Re: Laramie River Station 1-Hour SO<sub>2</sub> Characterization Report

# Modeling Report for Basin Electric Power Cooperative: SO<sub>2</sub> Characterization for the Laramie River Station

**Basin Electric Power Cooperative Responses to  
EPA Region 8 Comments Dated June 28, 2016 on:**

**April 2016 Modeling Protocol for Basin Electric:  
SO<sub>2</sub> Characterization for the Laramie River Station**

Figure 4-1 Location of Far-Field Receptors used in Dispersion Modeling

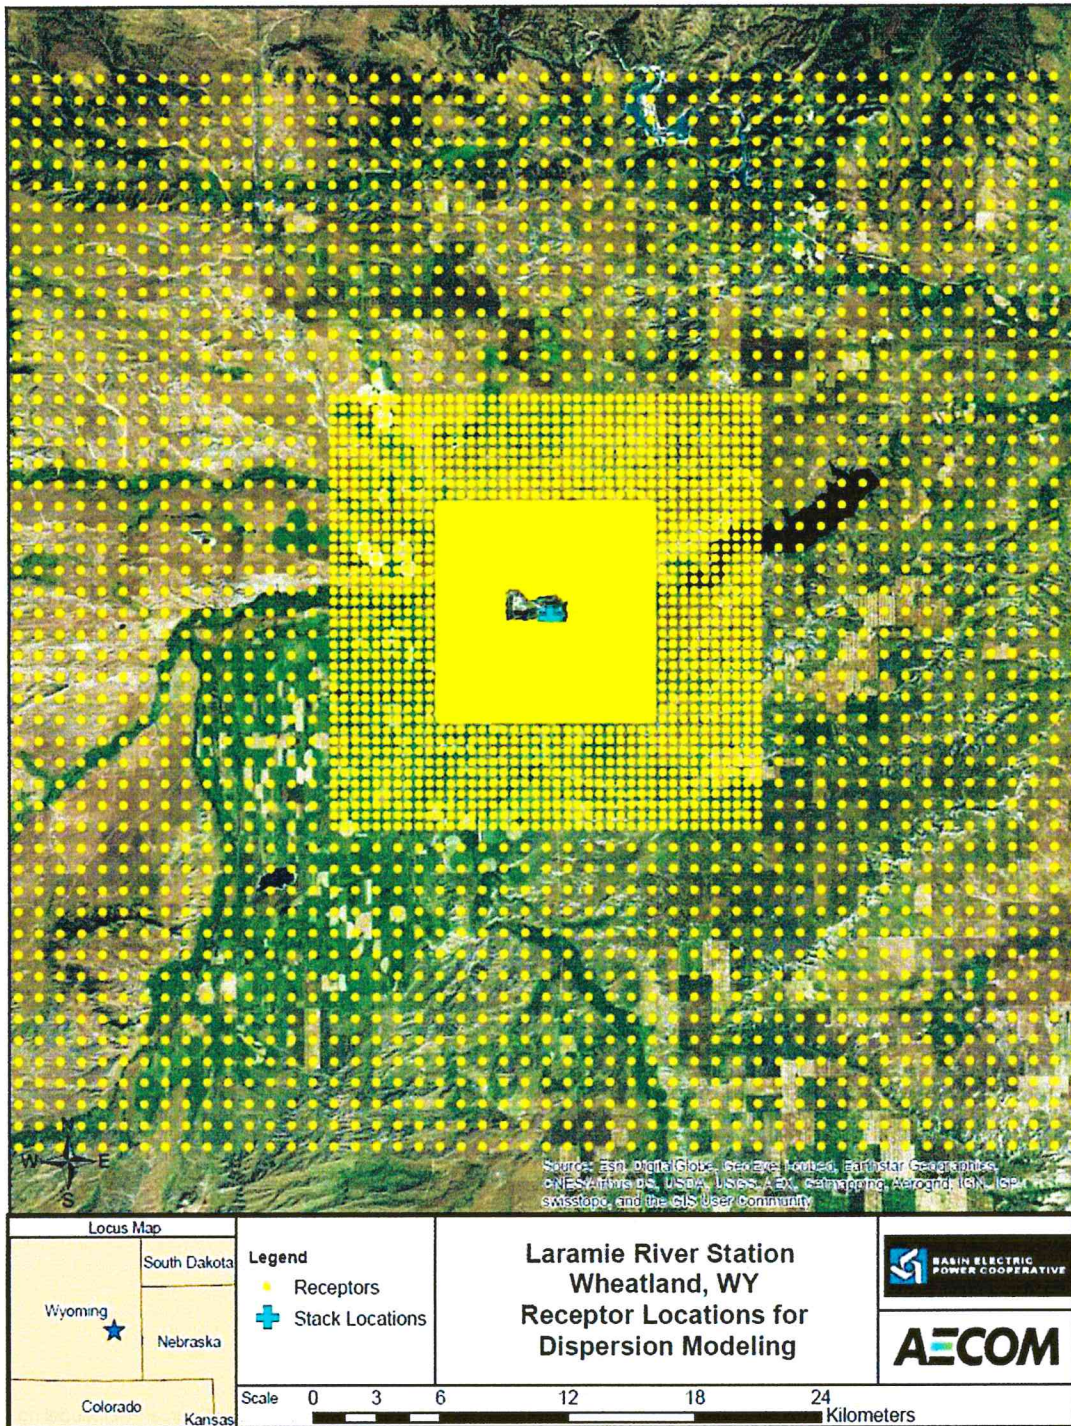
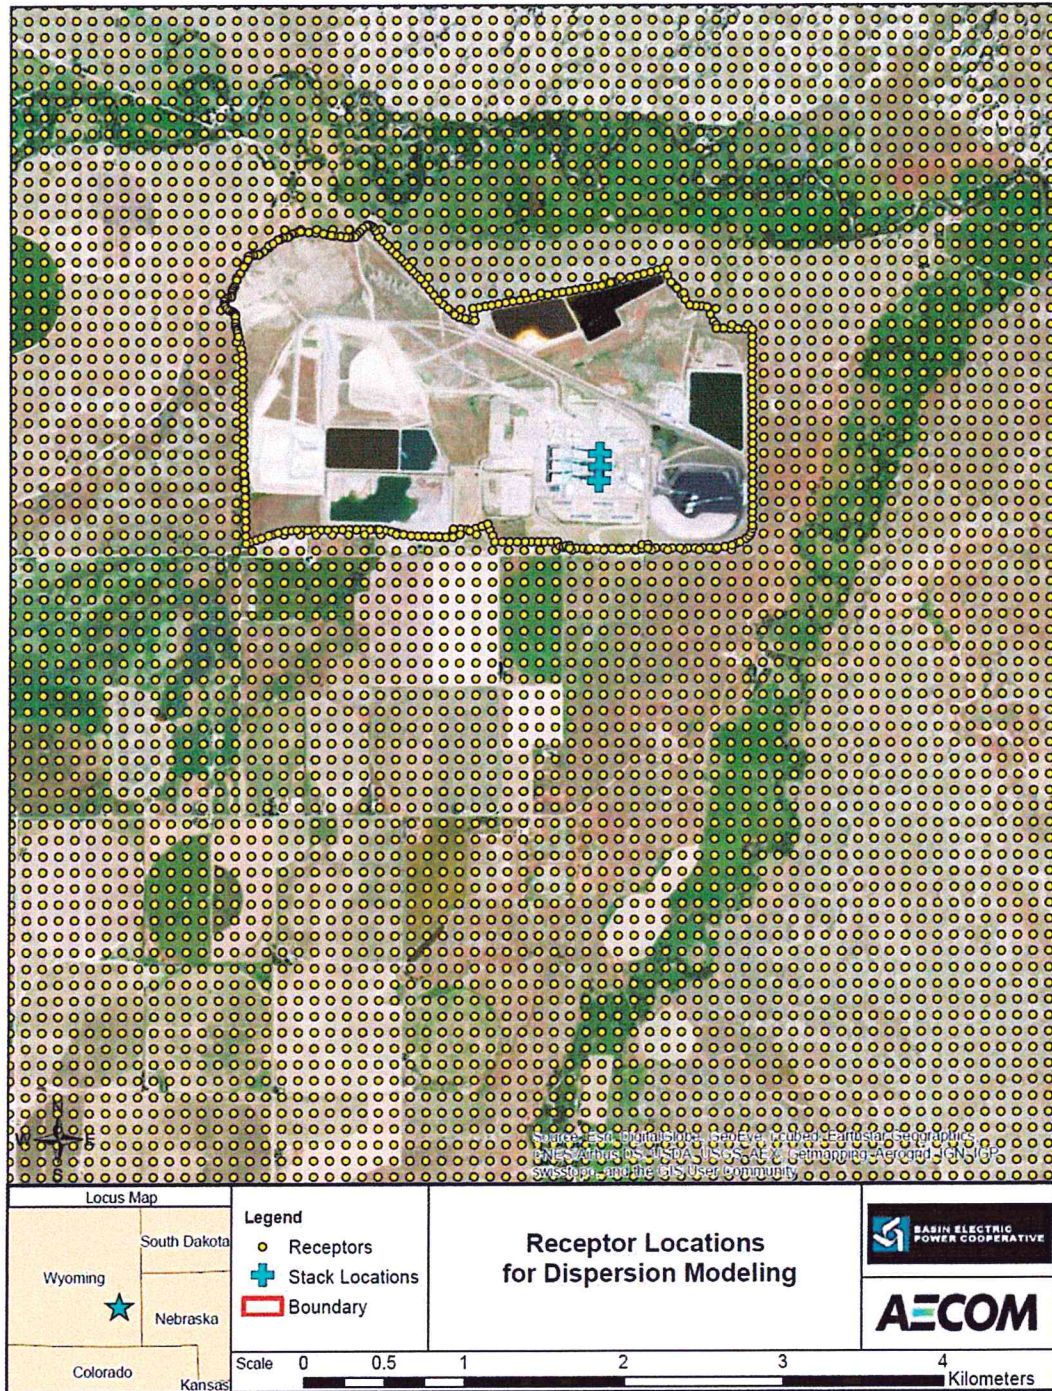
**Receptor Network [page 4-1]:** We recommend providing spatial maps of the receptor networks to better understand the receptor locations and their positions relative to the sources, the fence lines, or other important features. We recommend providing this information with the modeling protocol to assist in better understanding the receptor layout and ensure that a proper receptor network is used for the modeling analysis.

**BEPC response:** The revised protocol has been changed to include the requested figures of the receptor networks.

**Figure 4-6: Buildings and Stacks Included in GEP Analysis**

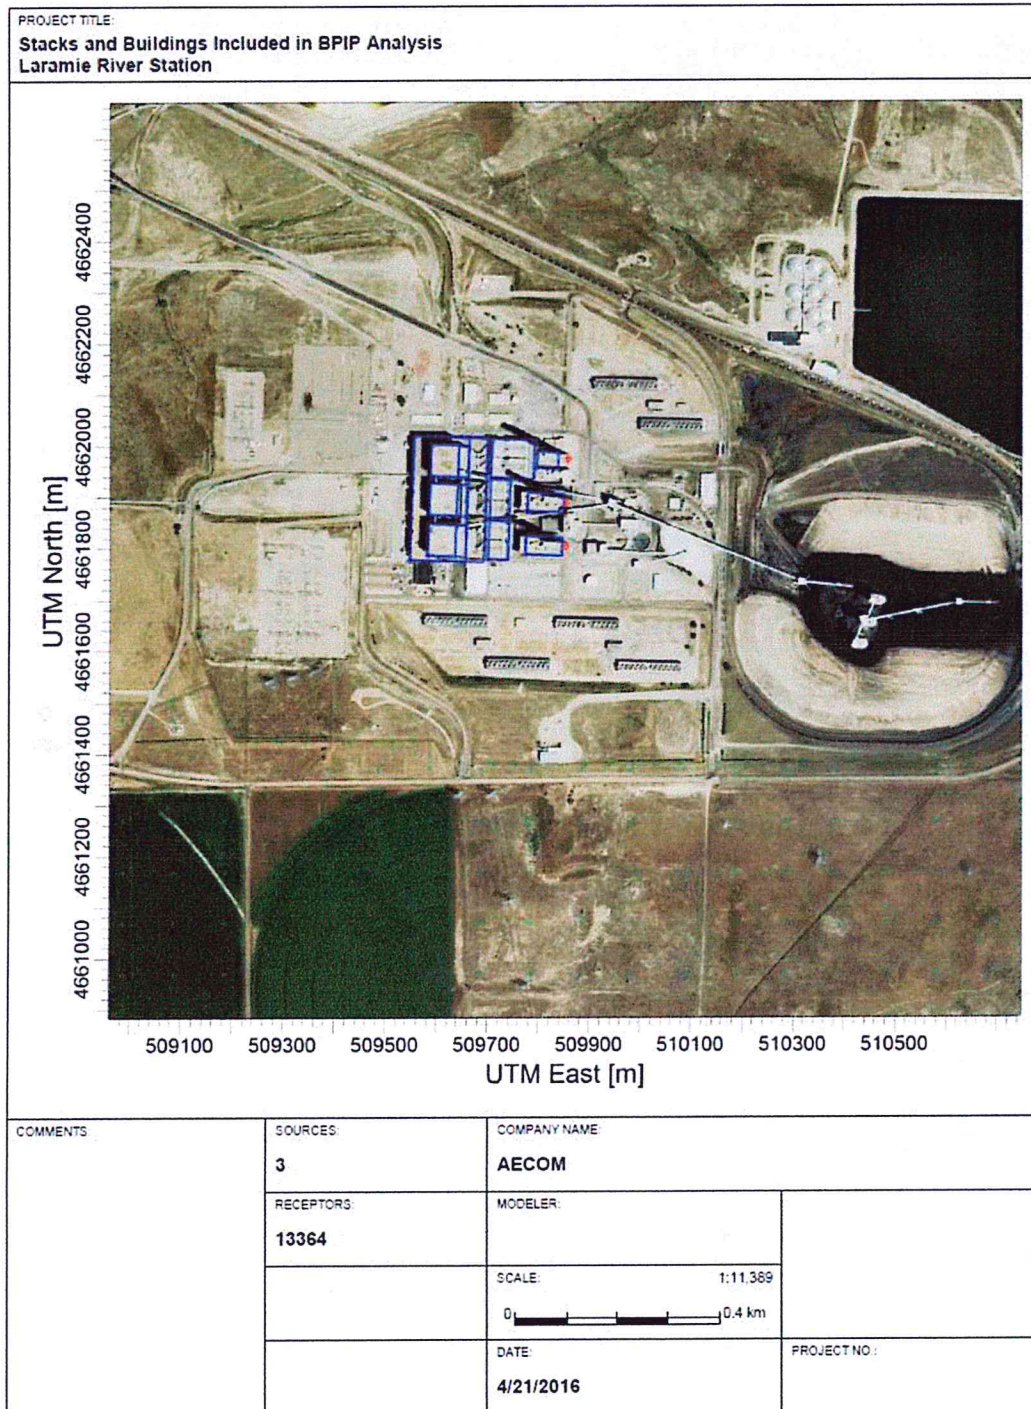
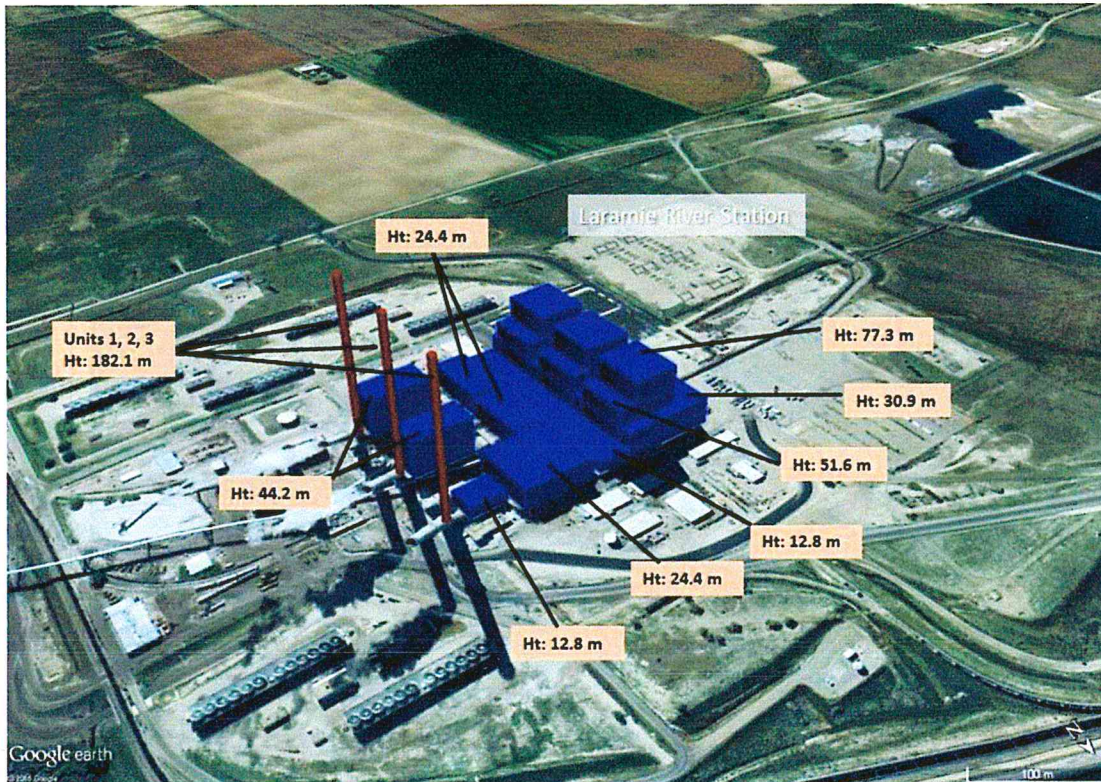
**Building Downwash [page 4-9]:** We recommend providing the building dimensions during the model protocol stage to ensure that disparities do not occur during the modeling efforts.

**BEPC response:** The revised modeling protocol will contain the requested information about building dimensions to be used in the modeling.
